United States Patent and Trademark Office

APPLICATION NO.	FILING DATE	FIRST NAMED INVENTOR	ATTORNEY DOCKET NO.	CONFIRMATION NO.	
09/737,770	12/18/2000	In-Duk Song	8733.339.00	8950	
30827 75	590 02/28/2006		EXAMINER		
MCKENNA LONG & ALDRIDGE LLP 1900 K STREET, NW			RUDE, TIMOTHY L		
WASHINGTO	•		ART UNIT	PAPER NUMBER	
			2883		
			DATE MAILED: 02/28/2006

DETAILED ACTION

FIG.2E

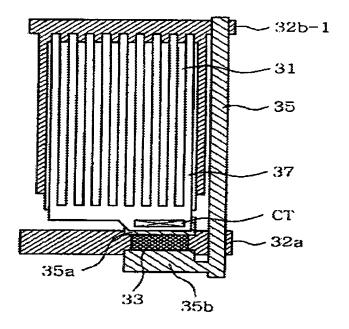
Jeon teaches 1) in Figures 2A-2E, an in-plane switching LCD device comprising: a gate line, 32a, on a first substrate; a data line, 35, on the first substrate, the data line being perpendicular (as illustrated) to the gate line; a common line, 32b-1, on the first

substrate, the common line being parallel (as illustrated) with the gate line and being formed of a metal (Applicant's first material, Cr for both gate line and common line; col. 2, lines 49-58, especially lines 55-58) (Applicant's wherein the common electrode is formed on the substrate like the gate line); a pixel electrode, 37, (ITO; col. 3, lines 18-22) and the common electrode, 31, (ITO; col. 2, lines 64-67) being formed of a transparent conductive material (ITO, Applicant's second material different from the first material); and a liquid crystal layer between the first and second substrates (inherent to comprising a LCD device) made by a method that simplifies the process by reducing the mask number.

FIG. I

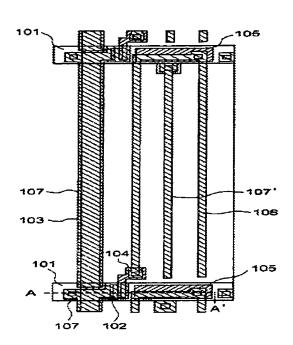
Ando teaches 2) [col. 6, line 29 through col. 8, line 46] a storage capacitor, 105, over the common line, 101, and between the pixel electrode and the first substrate, wherein the storage capacitor contacts the second connecting line, 106, via a contact hole per Figures 1 and 2 in order to comprise his invention for an in-plane switched LCD with improved aperture ratio [abstract].

FIG. 3

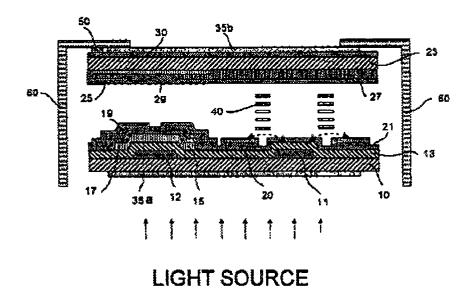
Son teaches in Figure 3, an LCD device, further comprising a light-shielding layer, 25, (Applicant's black matrix) on the second substrate, 23, (para 0029).
